Subject: C-10 Research & Education Foundation requests time to present during the upcoming May 7, 2025 Advisory Committee on Reactor Safeguards (ACRS) Full Committee (FC) meeting regarding Alkali-Silica Reaction (ASR) at Seabrook Station.

Assessment of NIST Shear Wall Tests and Their Relevances for Seabrook Station Safety

Assessment of NIST Shear Wall Tests and Their Relevances
for Seabrook Safety

ADVISORY COMMITTEE ON REACTOR SAFEGUARDS

Figure 1: In-plane and out-of-plane shear

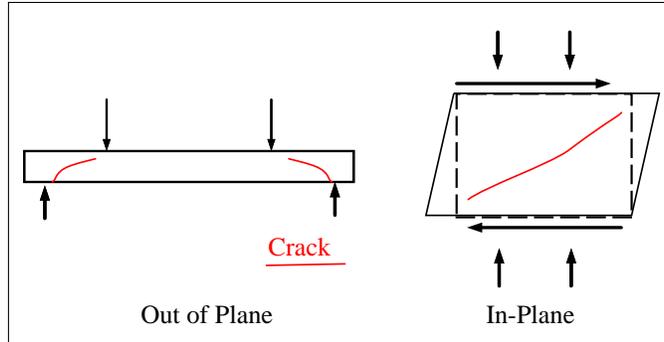
Membrane action refers to the internal force distribution in *thin-walled* structures where loads are resisted primarily through in-plane stresses (axial, hoop, and shear) without significant bending or transverse shear. It is characteristic of shells and plates subjected to smooth, distributed loading, Fig. 1.

In other words, the tests by NextEra are only applicable in discontinuity locations.

Figure 2: Identical test geometries used by Texas for TxDOT (Deschenes, Bayrak, and Folliard, 2009) and for NRC-sponsored testing (Bayrak, 2012). Both specimens are 332 inches long.

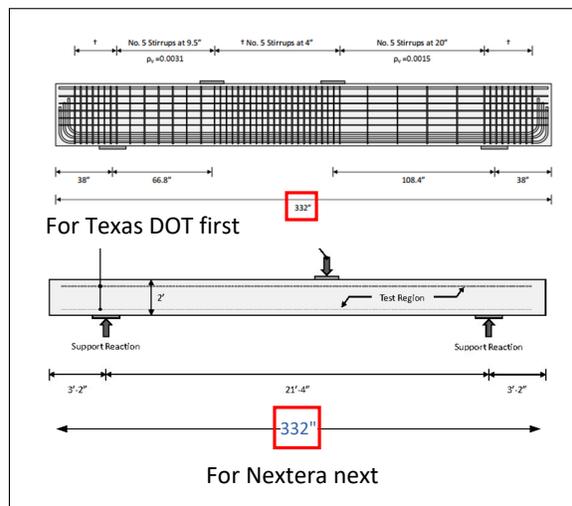
1. I conjecture that a few years earlier, Deschenes, Bayrak, and Folliard (2009) conducted tests for the Texas Department of Transportation using the setup shown in Fig. 2. Hence, by the time the LSTP started, those tests were completed. Remarkably, the dimensions of these girders are *identical* to those later selected for NextEra.

Figure 5: Experimental evidence of the variability of $E(f'_c)$ for Concrete with ASR; NIST and Bureau of Reclamation

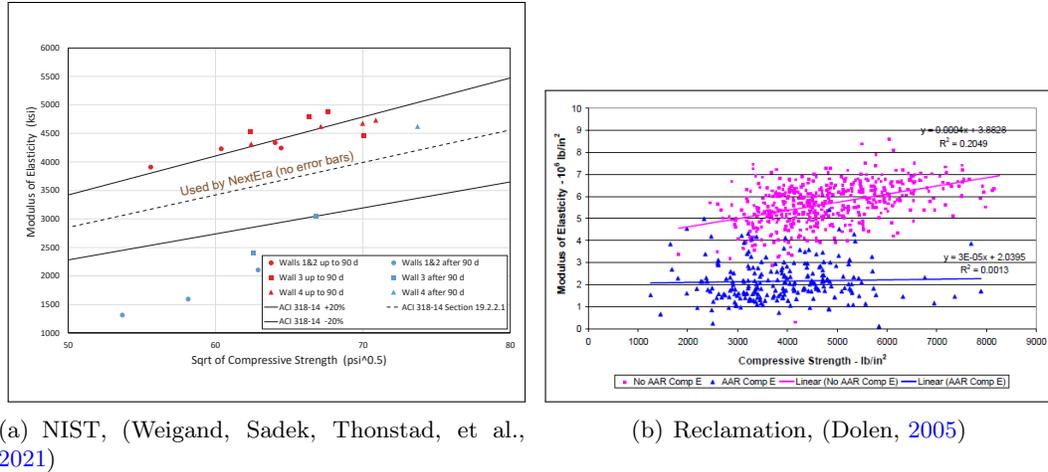
The NIST report clearly demonstrated the limitations of this equation, showing that it does not hold for ASR-affected concrete, as illustrated in Fig. 5.

Since the compressive strength data used for comparison correspond to specimens tested at 28 days (i.e., less than 90 days), we conclude—based on these findings—that the elastic modulus E is systematically **overestimated** by Eq. 1.

Figure 6: Why is the current monitoring procedure unconservative and dangerous according to the NIST report

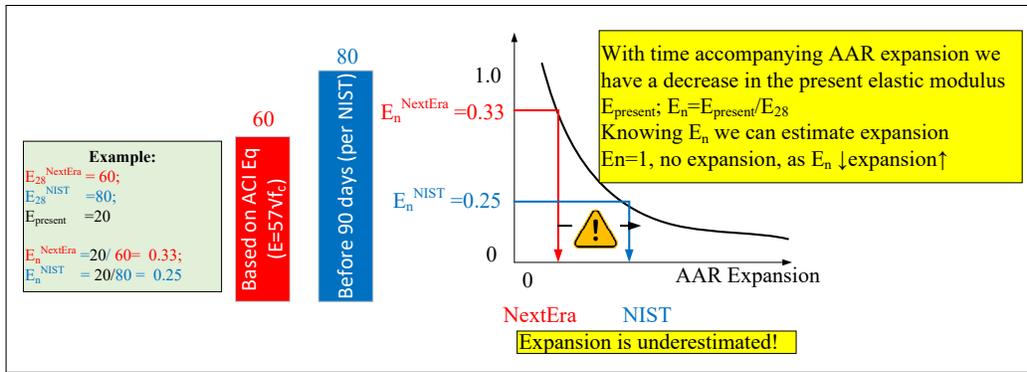
- NIST found that E_{28}^{NIST} is larger than E_{28}^{NextEra} .
- This directly implies that the normalized modulus values—defined by Eq. 2, where E_{28} appears in the denominator—are also larger for NextEra:

- Based on the calibration curve (developed under the LSTP) that relates normalized elastic modulus to ASR expansion, this discrepancy leads to an **underestimation of the actual expansion**.

Figure 7: Impact of **uncertainties** associated with the determination of past expansion

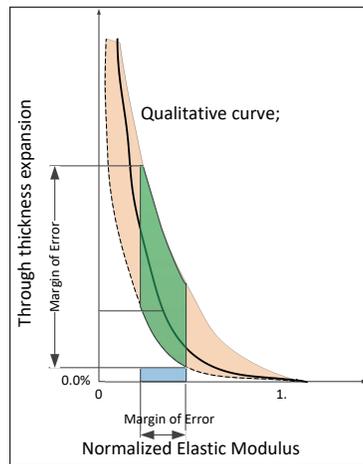
Both of these components are subject to significant uncertainty¹, which must be explicitly acknowledged and incorporated into the evaluation.

The magnitude and implications of these uncertainties are illustrated in Fig. 7.

expansion at Seabrook, the uncertainties should be explicitly accounted for—such as by including margins of error (Fig. 7).

Figure 10: Texas shear tests (Wald, Martinez, and Bayrak, 2017), (note splitting crack, explained in C.2)

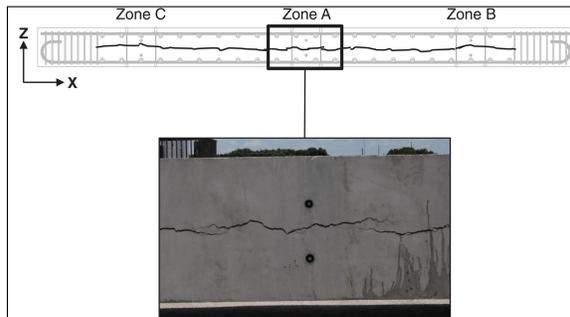
Texas Not only was the LSTP (Large Scale Test Program) conducted by the University of Texas, Fig. 10, upon which the NRC (Nuclear Regulatory Commission) heavily relied for issuing the license to operate Seabrook, the least relevant, but it was also flawed due to the presence of a large unintended pre-test crack. This factor should cast many doubts on the reliability of its results. The report concludes that shear

strength increased—without disclosing the quantitative data supporting this claim.
